REMARKS

Amendments to the Drawings

FIG.8

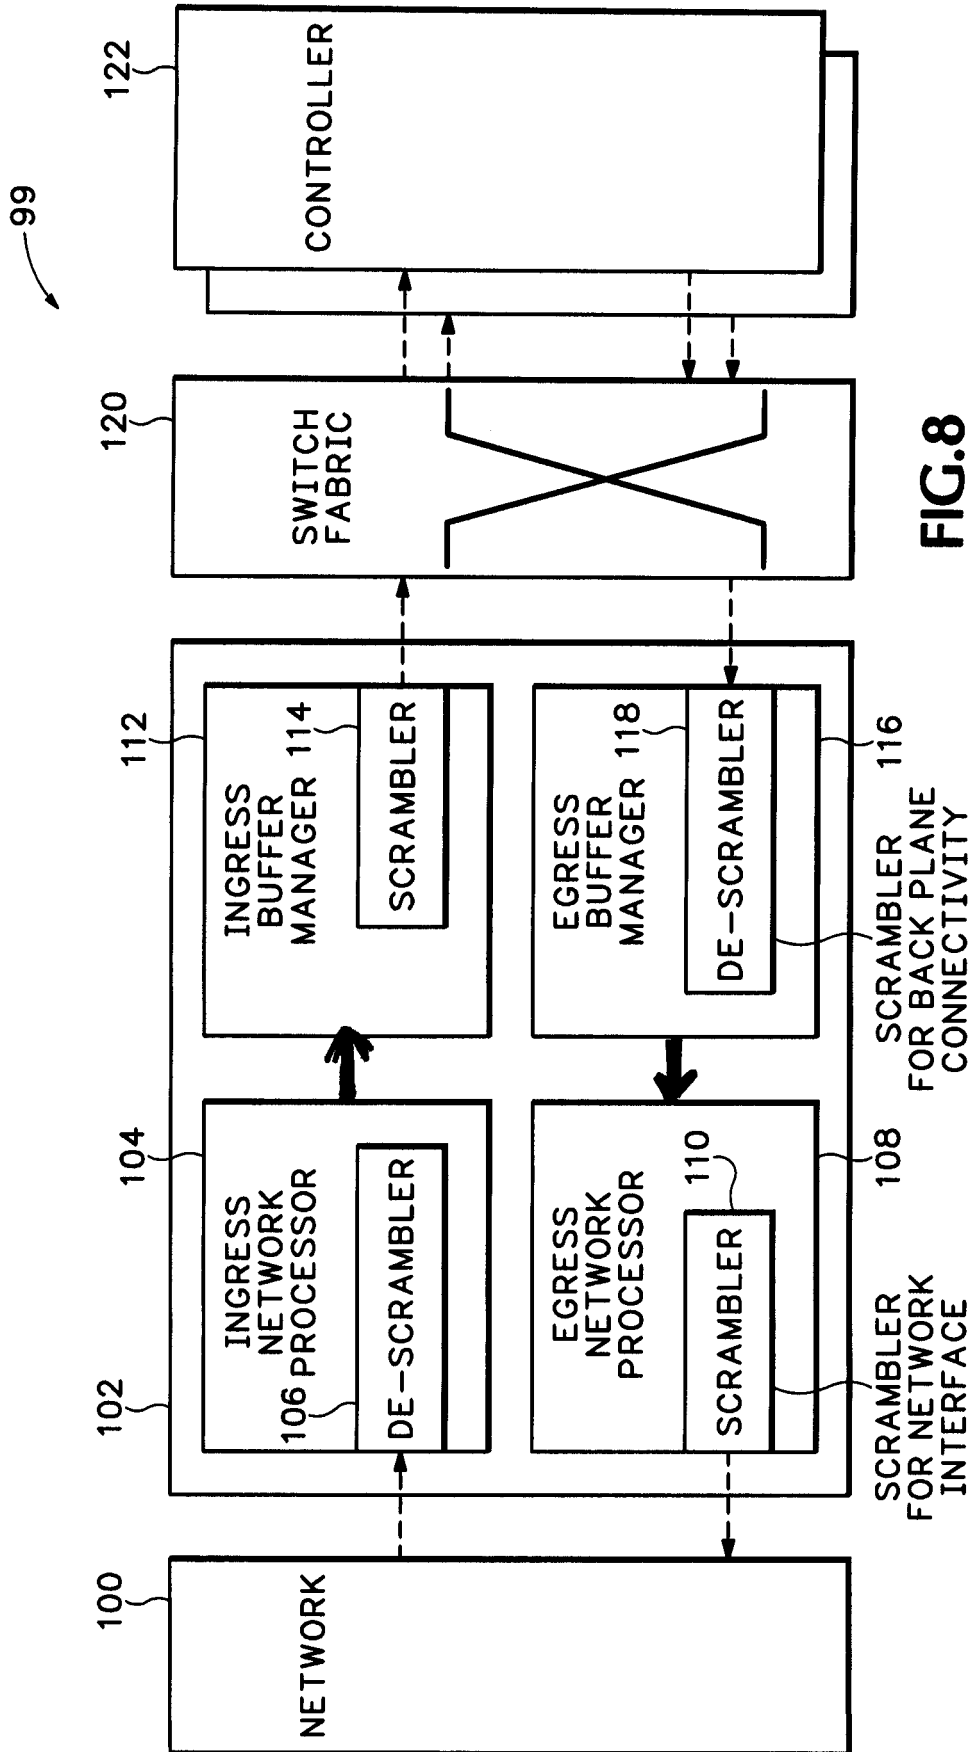
The Office Action indicates several potential informalities in the drawings. First, the Office Action indicates that Figure 4 contains a misspelled label "Scambler Polynomial." Second, the Office Action indicates that Figure 8 contains incorrect flow directions between elements 104 and 112 and between elements 116 and 108. Applicants were able to locate the version of the drawings to which the Examiner was referring, and apologize for their confusion. Figures 4 and 8 have now been updated to address the informalities identified by the Examiner.
